Piqua, Ohio, Decommissioned Reactor Site Characterization Survey Plan Addendum

Figure 3. Room B-7 ACS Wall Survey Measurement Locations

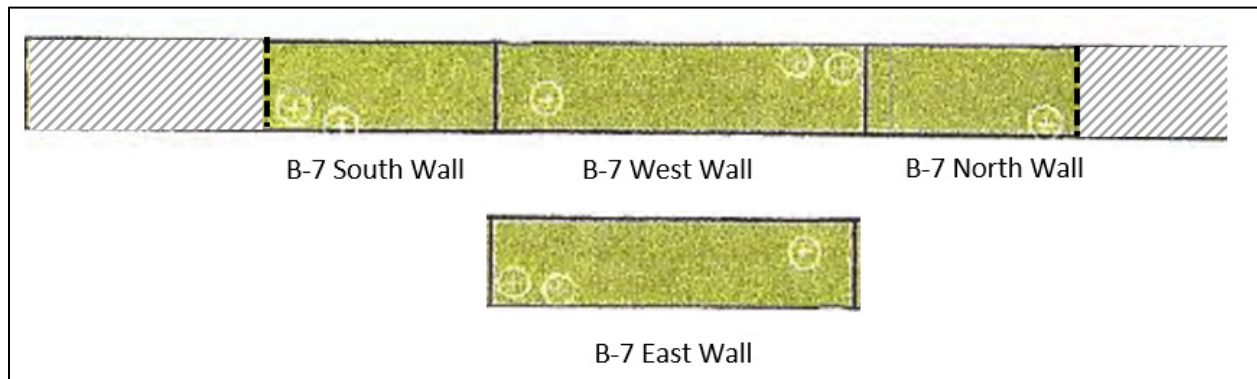
In the original CSP, Rooms B-7 and B-8 were identified as a single MARSSIM survey unit. As such, the required number of survey measurement locations for the survey unit were appropriately split between the two rooms based on the random start location of the symmetrical grid placement that the Virtual Sample Plan (VSP) software created (a software program specifically written and used for radiological release surveys like the CSP [Figures 1 and 2]). On the original survey location map of the two rooms, 15 survey measurement locations are identified on the walls (up to 6 feet above the floor) and on the floor. This is consistent with the requirements identified in the CSP for a Class 1 survey unit, including Rooms B-7 and B-8 (as a single survey unit). Room B-7 contained 5 of the 15 floor survey measurement locations and 6 of the 9 total wall measurement locations (between the shared north and south walls and the sole west wall of B-7). However, an east wall was identified for Room B-7 that was not identified on the survey plan drawings and not populated with survey measurement locations. Given the survey unit separation of the two rooms, there should be as many survey locations on the east wall of Room B-7 as there were on the west wall. That said, three additional survey measurement locations need to be added to the east wall of Room B-7. In total, nine wall survey measurement locations and five floor measurement locations are required to complete the ACS of Room B-7, to be in line with the original CSP MARSSIM requirements. For Room B-7, an east wall survey measurement location figure has been added, and the original north and south wall figures have been split between the two rooms to represent the survey measurement locations for Room B-7 (Figure 3).

As permitted in MARSSIM and the original CSP, random start systematic grid survey locations can be moved or adjusted based on physical interferences or for survey or safety concerns. This allowance holds true for Room B-7. Because a large tank exists in the room, survey measurement locations can be moved or adjusted to the closest location that can be accessed safely. If a planned survey measurement location is moved, then the new survey measurement location shall be identified and recorded in ACS results documentation.
